Application for Major Site Plan Review

Service High School Major Maintenance Grant- Buildings B and EF
MOA Permit C13-2026 / Change Order X14-1997
Site Plan Administrative Review-MOA Original Case Number 2001-028 Site Plan Review
11/6/2015

SERVICE HIGH SCHOOL RENEWAL-BLDGS. B & EF
MAJOR MAINTENANCE GRANT
ANCHORAGE SCHOOL DISTRICT
ANCHORAGE, ALASKA

Figure 4B: Revised Plan

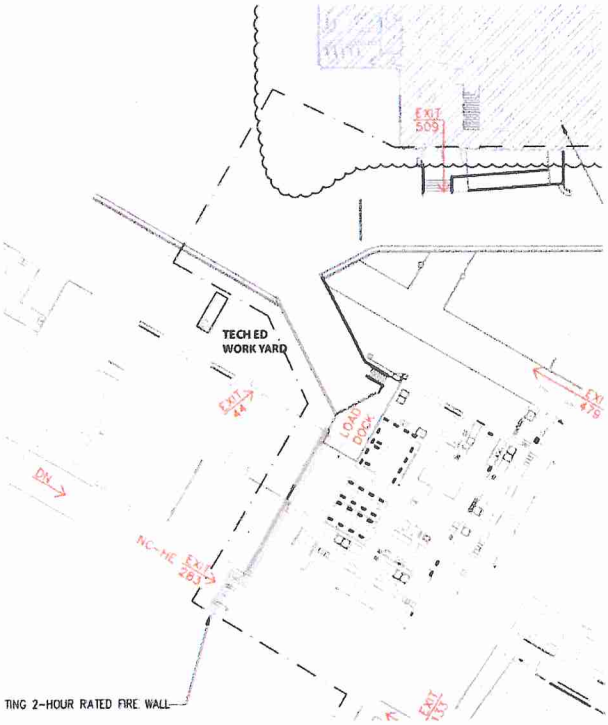
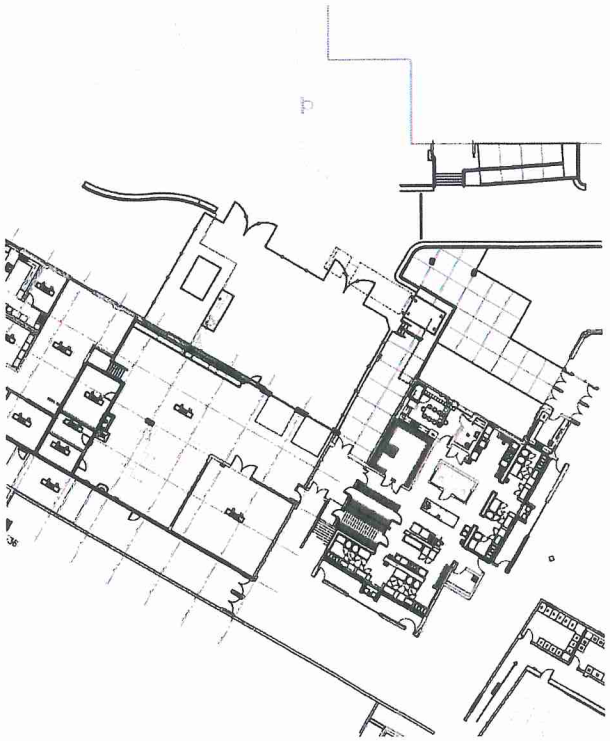
The requested revision is a change in the configuration of the Food Service Loading Dock and adjacent Technical Education Work Yard from as shown on the M.O.A. approved documents under permit C13-2026. The approved building permit drawings indicate a depressed vehicular ramp sloping (-) 3'-0" below grade to a conventional loading dock which in plan angles diagonally towards the existing sectional overhead doors that connect the Technical Education Shop and Classroom interior areas with the Technical Education exterior work yard. See below Figure 4A.

The revised design eliminates the depressed vehicular ramp to the loading dock due to safety concerns with the depressed ramp design- the principle of Service High School didn't want to create a ramp that might encourage skate boarding, or a location where students could hide. The permitted vehicular ramp also negatively impacted the Technical Education program's exterior yard. Student construction projects are typically started inside the shop and then are moved to the exterior work yard. The overhead garage doors connecting the shop interior to the work yard need clear space in front of them to feasibly move the small structures that the program constructs out into the yard. The depressed ramp design didn't allow for this. The design was revised to eliminate the depressed vehicular ramp which enabled the Technical Education's yard to function as it needs to. See Figure 4B above. The existing Technical Education work yard was approximately 2582 square feet in area- see Figure 5 below. The Revised Plan shown in figure 4B is approximately 2970 square feet in area.
